HISTORIC LANDMARK COMMISSION
JANUARY 28, 2019
PERMITS IN NATIONAL REGISTER HISTORIC DISTRICTS
NRD-2019-0002
3104 GLENVIEW AVENUE
OLD WEST AUSTIN HISTORIC DISTRICT

Replace non-original siding and windows and enlarge primary entrance opening.

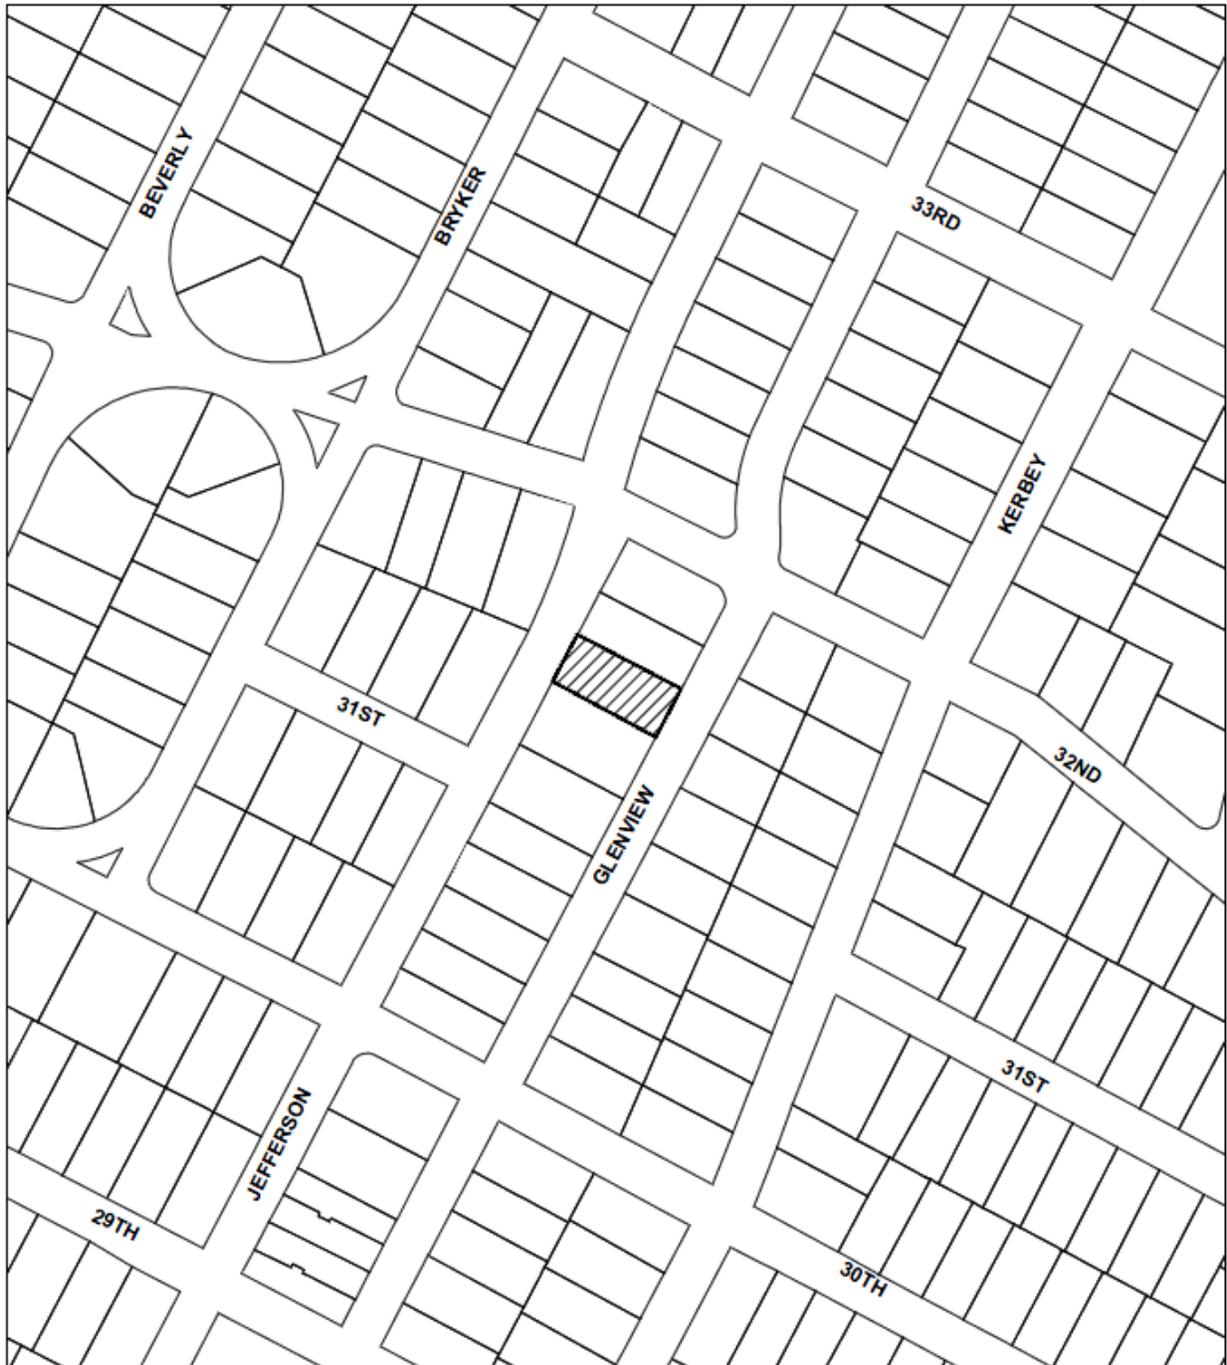
The proposed project replaces non-original siding and windows with newer materials with similar proportions. It also roughly doubles the width of the primary entrance, which is a character-defining feature of the house.

It is not clear if the door is original. The siding and windows to be replaced are not original.

The larger front door opening is not particularly compatible with the style of the house. It will be differentiated from the historic features and other openings by its double width.

The proposed project partially complies with the Secretary's Standards.

Comment on and release the plans.
